TIVERTON WASTEWATER DISTRICT

SEWER CLEANING, CCTV SEWER, MANHOLE AND SOIL EROSION INSPECTION SERVICES

Solicitation No. 26-002

Addenda No. 2

Schooner Dr. Pump Station Excerpt from plans developed for construction (as-built plans are not available).

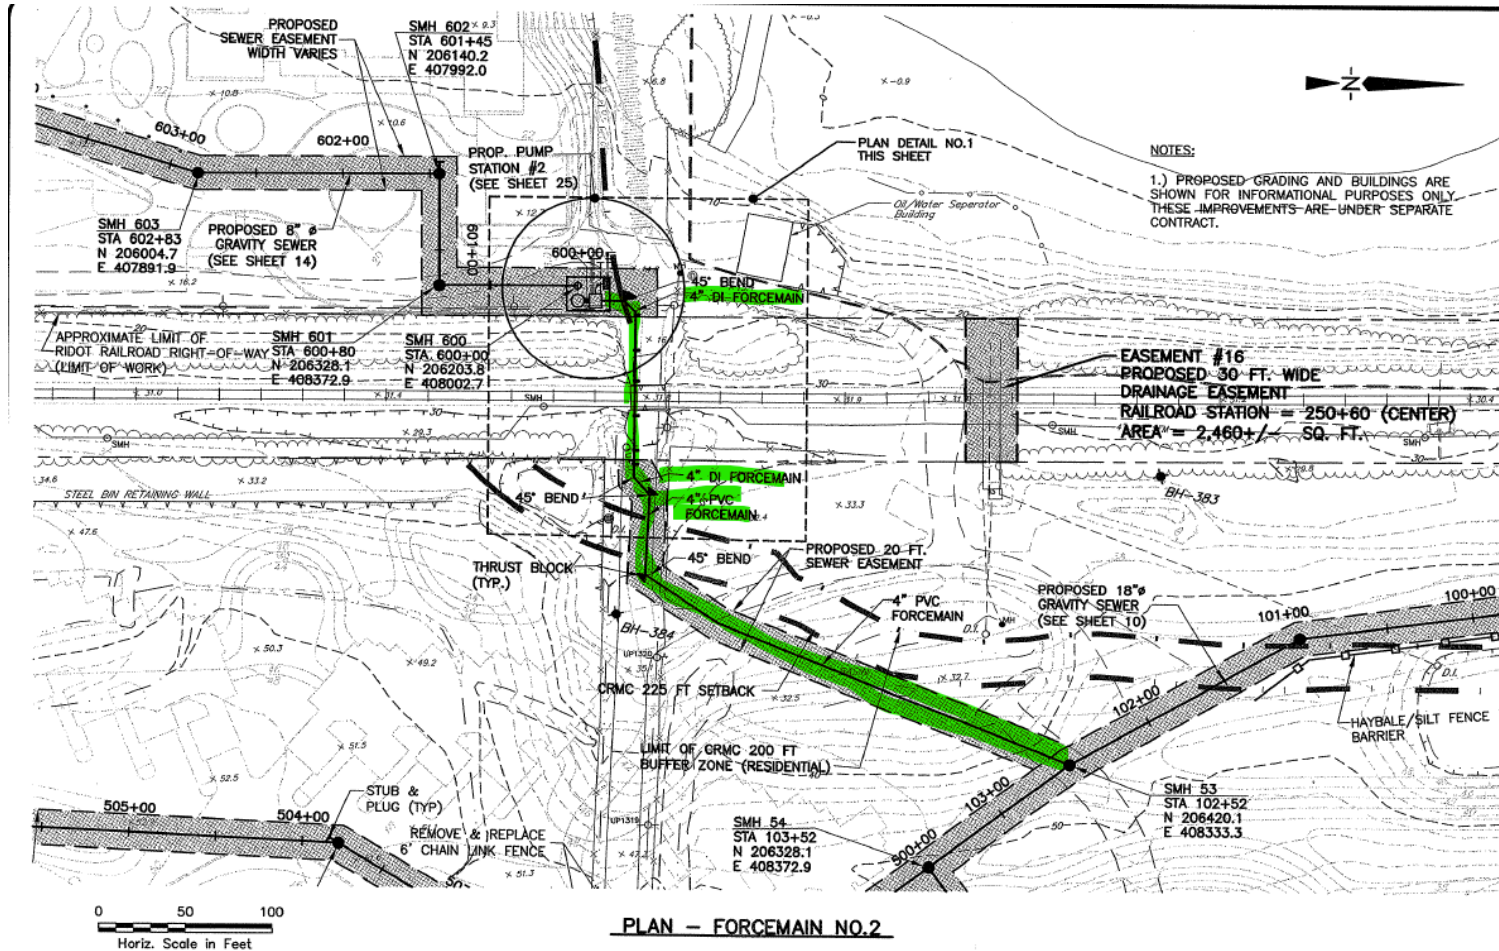
3. Please confirm the minimum pipe diameter required to be inspected under this contract. The bid items on page BID-1 reference pipe sizes of "6 through 24 inches," while pages TS-2 and TS-6 reference pipe sizes of "4 to 24 inches." Please clarify which requirement governs?

Response: Sorry for the confusion. Bid-1 is hereby revised to 4 through 24 inches. As noted in Appendix B, there are two 4" force mains: Schooner PS FM at 433 linear feet and Blackbird Court PS at 1385 linear feet. It is not anticipated that Blackbird Court PS force main will be selected by TWWD for inspection. The low-pressure sewers listed in Appendix B of the RFP with diameters less than 4" are not included in this contract.

Please note that the TWWD will be responsible for shutting down the pump stations, monitoring wet well levels and emptying the force main during the inspection.
